ADDENDUM NO. 1

Job No. F70C616E
SAND ISLAND STATE RECREATION AREA
SEWER SYSTEM IMPROVEMENTS
PHASE 2: PUMP STATION 3 RELOCATION & FM 3 REPLACEMENT
Honolulu, Oahu, Hawaii

02/22/21

| 1 | ADDENDUM NO. 1: REVISED DUCT SECTION | 23 of 25 | 2/19/21 | | |
|--------------|--------------------------------------|---|---------|--------------------|----------|
| APPROVED: | | | | DRAWING NO. E-5 | |

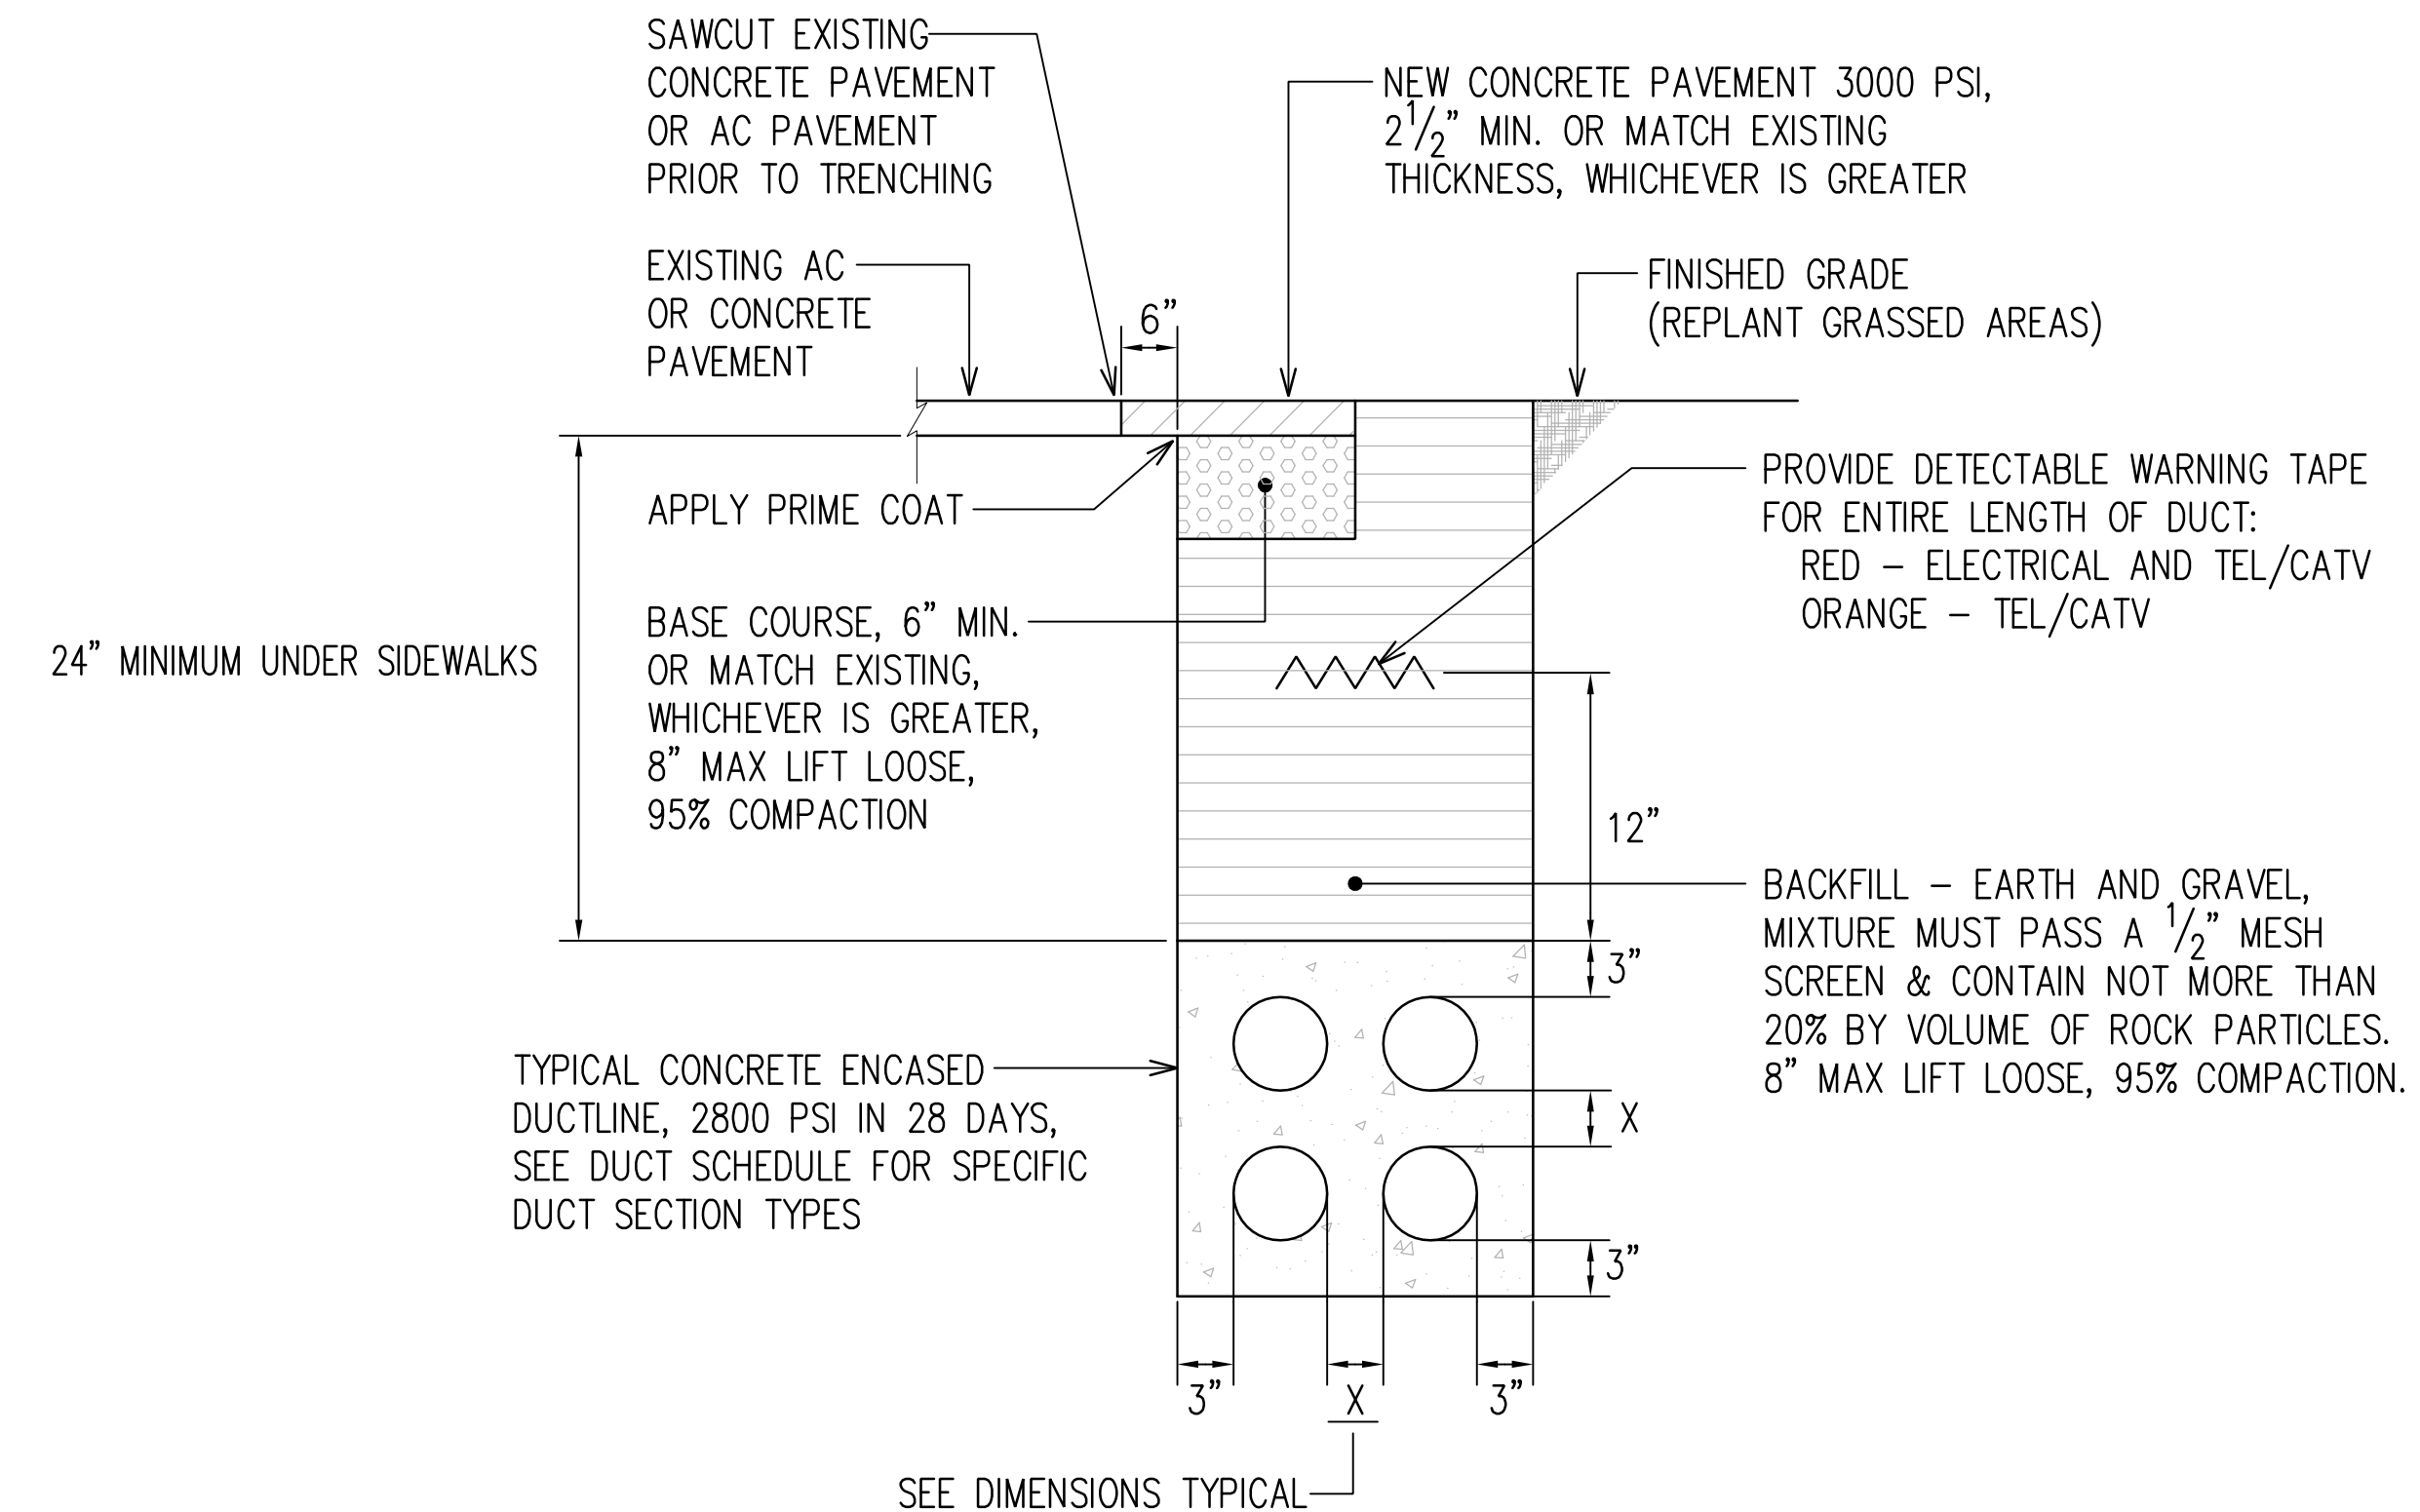
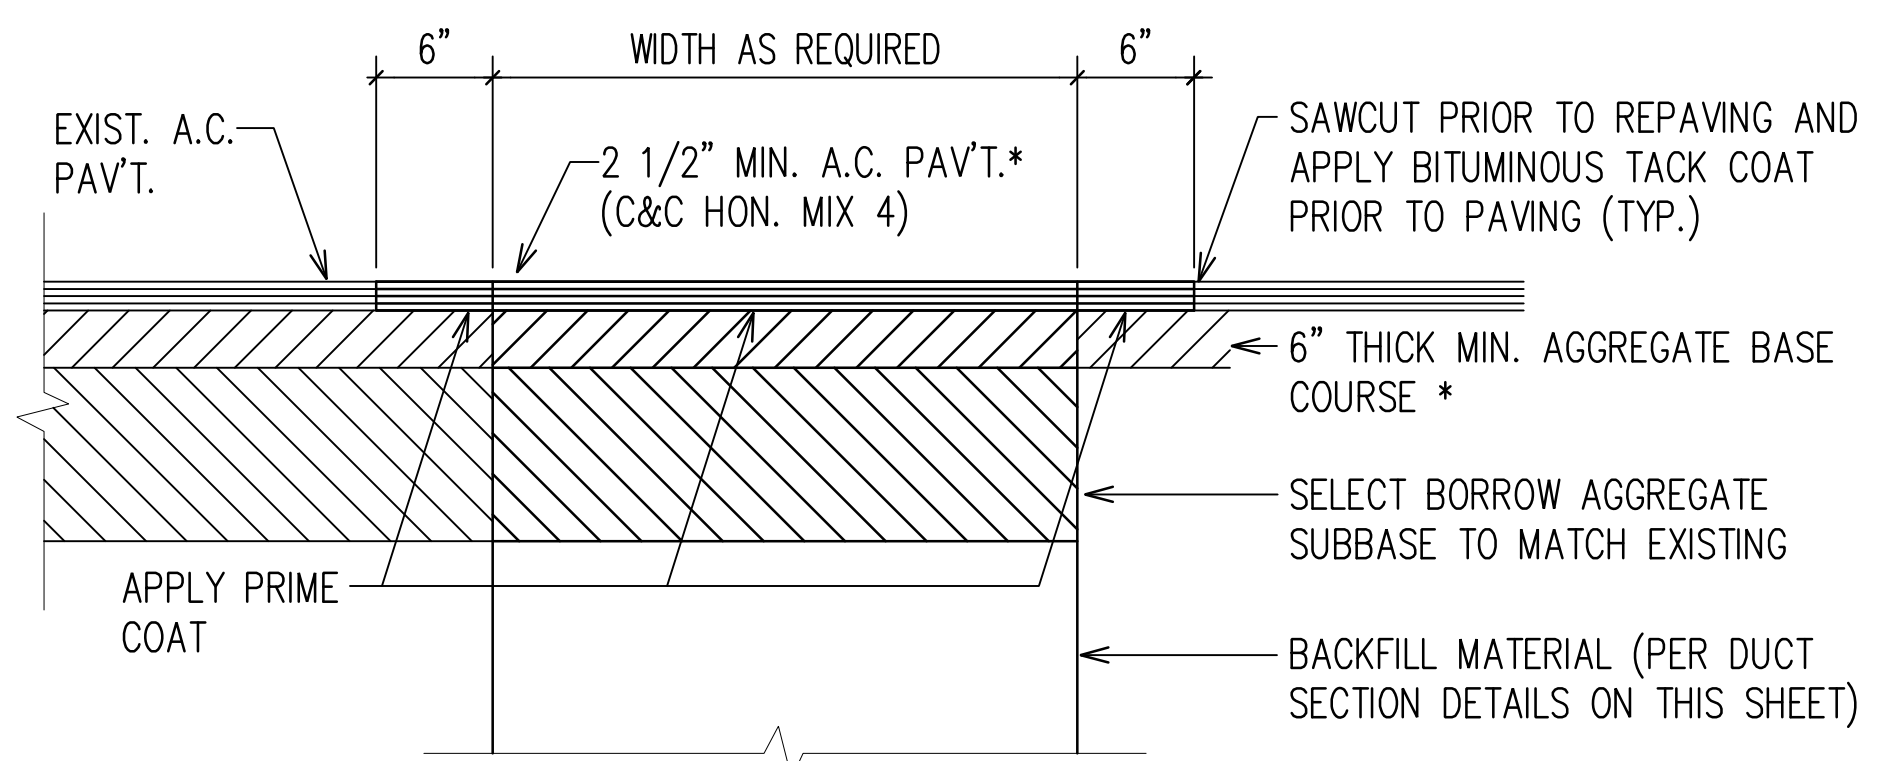
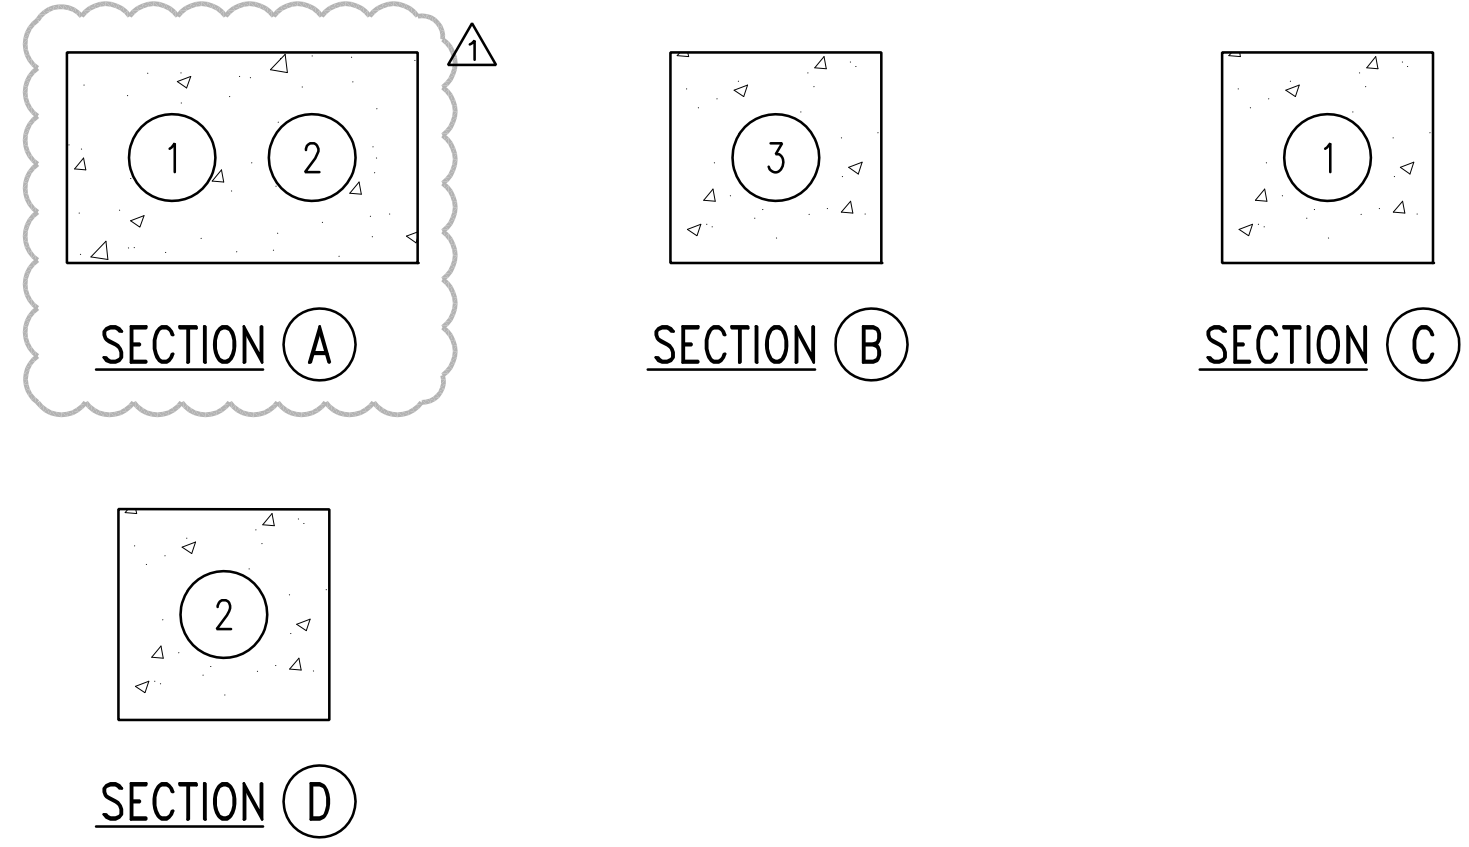
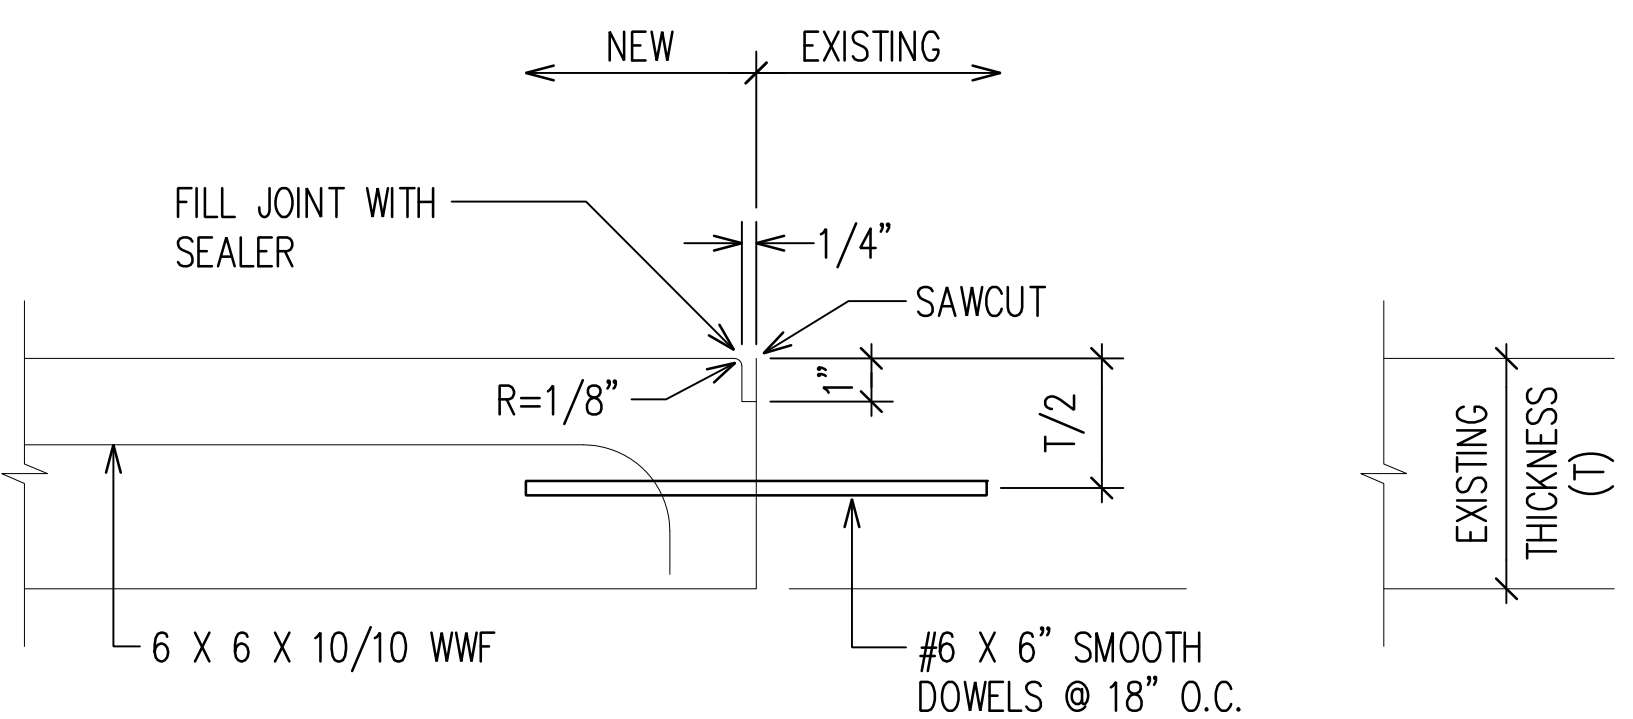
- 17. Sheet E-5, “Duct Section Details”:
 - a. Revised duct section A to match what is shown on new site plan.
- 18. Sheet E-6, “Comfort Station #6 Revised Electrical Plan”:

55. Per the duct schedule on sheet E-5 there is 1" Conduit; However, there is not a pay item for 1" Conduit. Please provide a pay item for 1" Conduit.

57. On Specification sheet 16301-4 > Part 2 - Products > 2.01 Materials > C. Ducts > Note 1. specifies all conduits to be encased in 3000psi minimum concrete. On sheet E-5, Typical Trench and Backfill Detail notes specify concrete encased ductline to be 2800psi concrete. Please confirm if 2800psi is acceptable for ductlines.

Answer: Revised items 36 and 44 from ¾" C to 1" C. Proposal schedule revised and item numbers have changed. See the revised proposal schedule in this addendum.

Answer: Concrete shall be 3000psi per referenced spec section.
